ADDENDUM NO. 2

**STOUT FIELD BUILDING 18
MILITARY INTELLIGENCE BATTALION CONVERSION
INDIANAPOLIS, INDIANA**

IFB NO: MDI-SAB-24-B-014

GEDA Architects

1. MINIMUM 2'-0" FROM END OF DUCT.
2. CURVATURE OF GRILLE TO MATCH OUTER DIAMETER OF DUCT.
3. UTILIZE PAINT GRIP FINISH ON DUCT AND GRILLE.

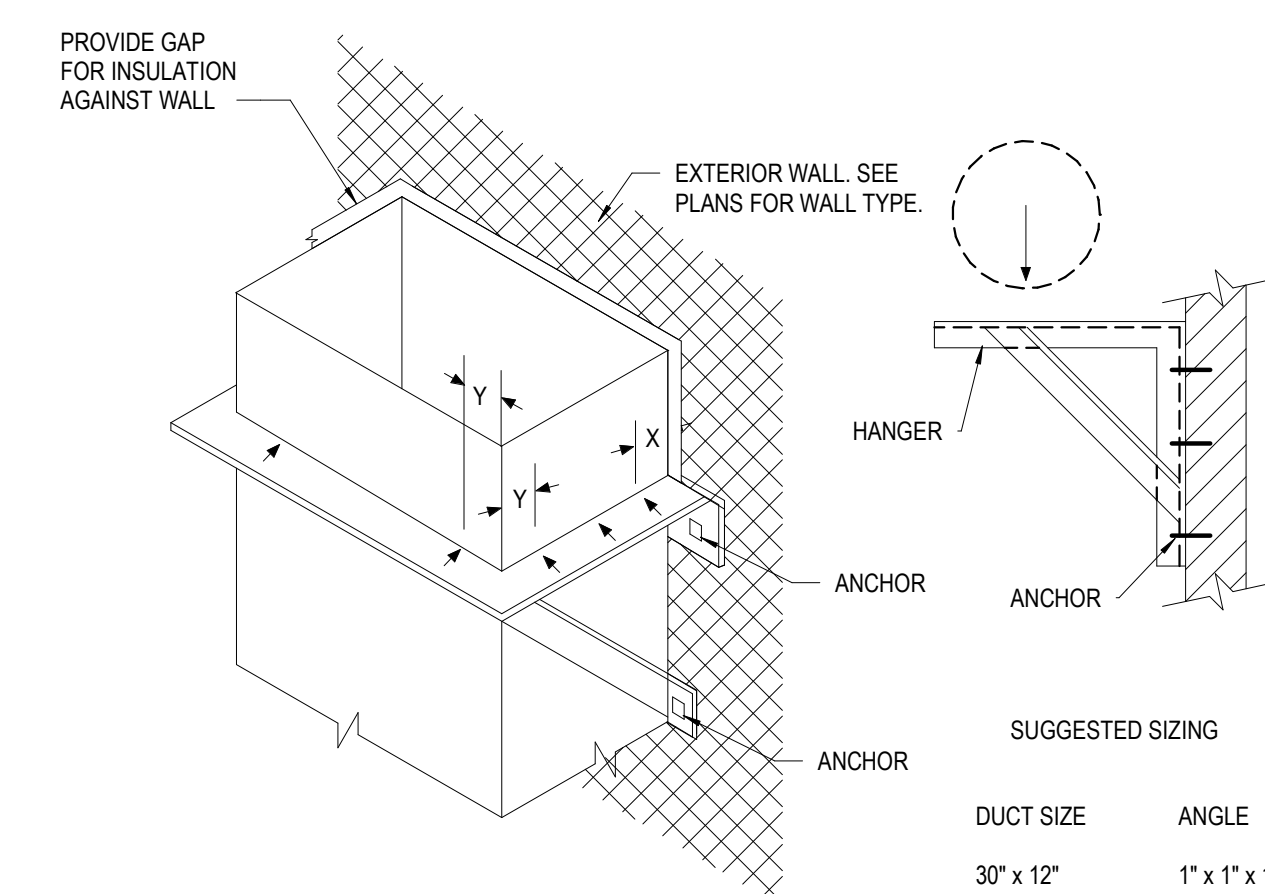
11. Sheet M502 – MECHANICAL DETAILS
 - Added detail number 5 to sheet.
